Ground-Water Monitoring Of Lower Los Alamos Canyon  
Meeting Notes February 19, 1993

## ATTACHMENT A

Amendment to summary of 2/19/93 meeting notes: Ground-Water Monitoring Issues in Lower Los Alamos Canyon.

Figure 1. Monitoring well transect locations.

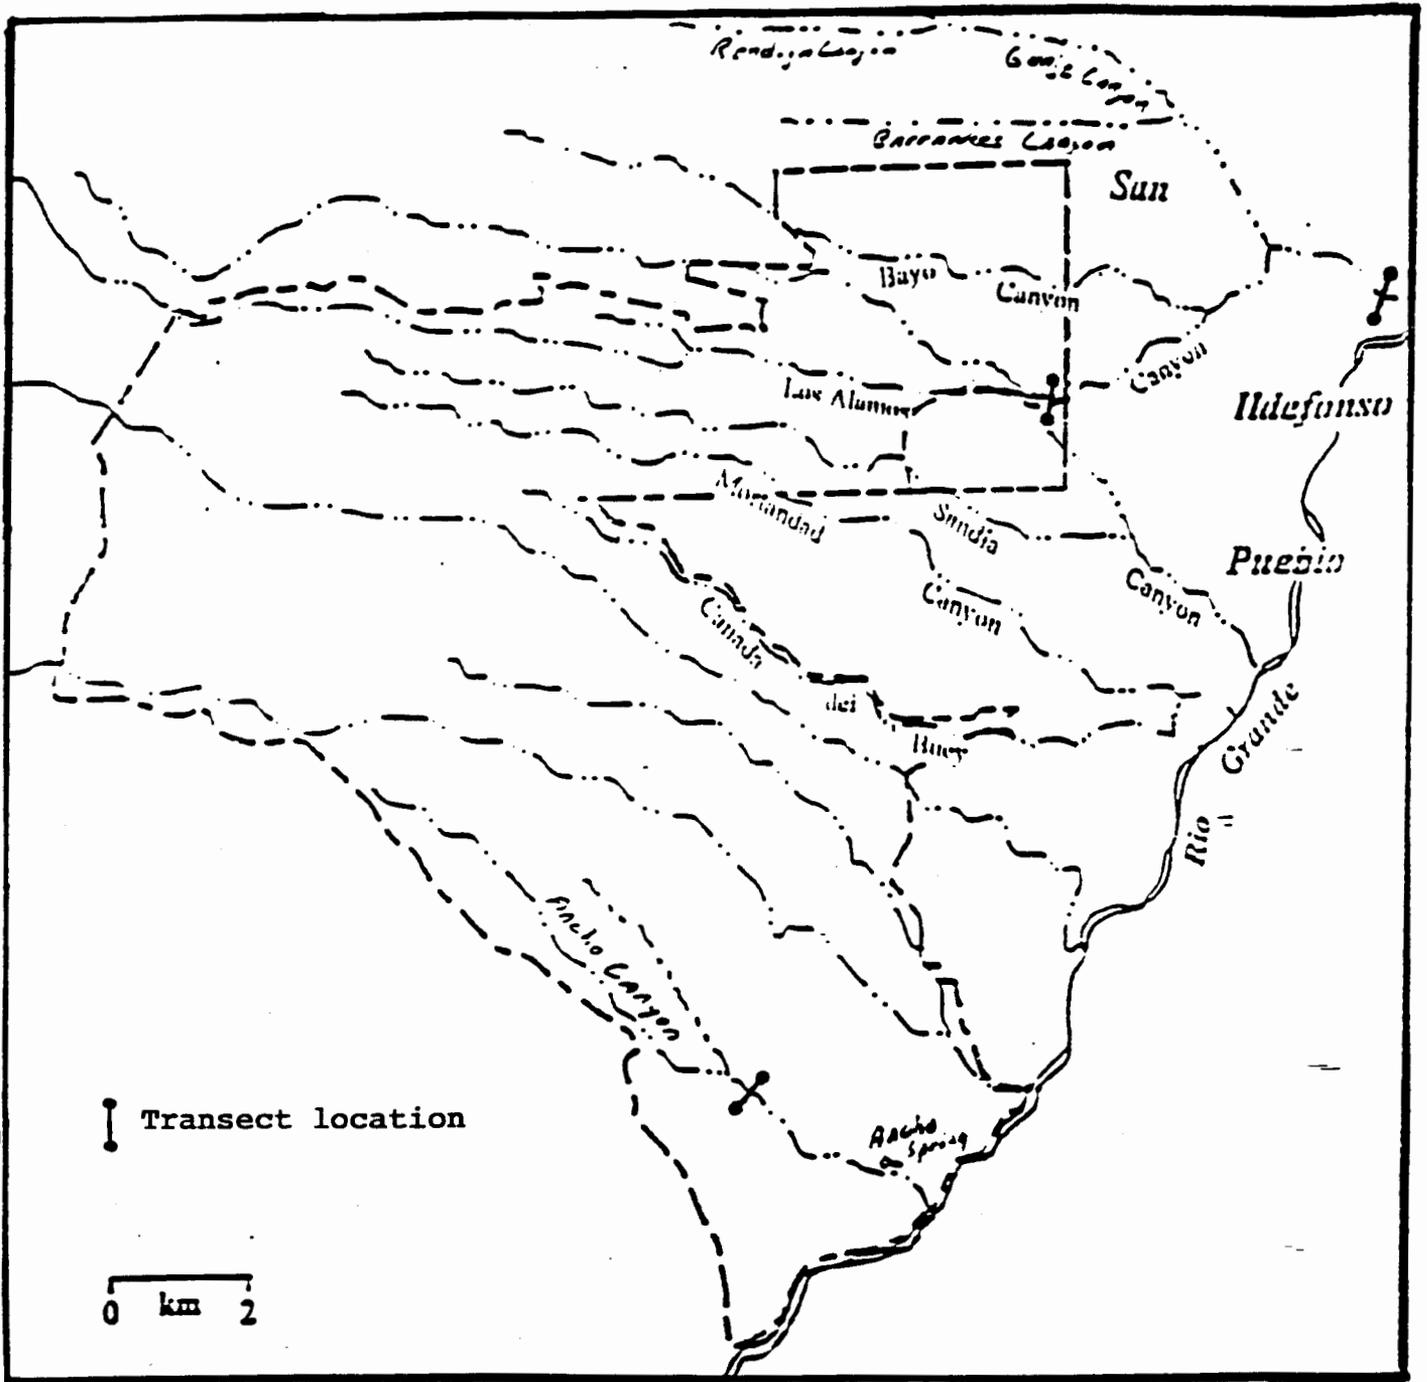
**Los Alamos Canyon, downstream of Pueblo-Los Alamos Canyon confluence near Lab boundary (Fig. 1):**

**Los Alamos Canyon, downstream of Guaje-Los Alamos Canyon confluence (Fig. 1):**

**Ancho Canyon, downstream of the confluence above Ancho Spring (Fig. 1):**

Recommended transects across the perched-alluvial systems are shown in figure 1. It is recommended that at least three wells be installed per transect. Recommended methodology can be found in the Resource Conservation and Recovery Act, Technical Enforcement Guidance Document (TEGD). Paired wells may be necessary if the depth of the aquifer can not be fully monitored within TEGD recommended screen lengths. The ultimate decision for the siting of monitoring wells on San Ildefonso property rests with the Pueblo and access to these wells would be on a Pueblo permission-only basis.

If saturated conditions are not encountered upon completion of one monitoring well in the perched-alluvial aquifer downstream of the Pueblo-Los Alamos Canyon confluence, it is recommended that monitoring wells be drilled into the perched basalt-conglomerate aquifer. Also, it is suggested that three monitoring wells be installed in Ancho Canyon (Fig. 1) contingent upon completion of one monitoring well encountering saturated conditions. If saturated conditions are encountered, two additional wells would be installed transversely across the stream channel.
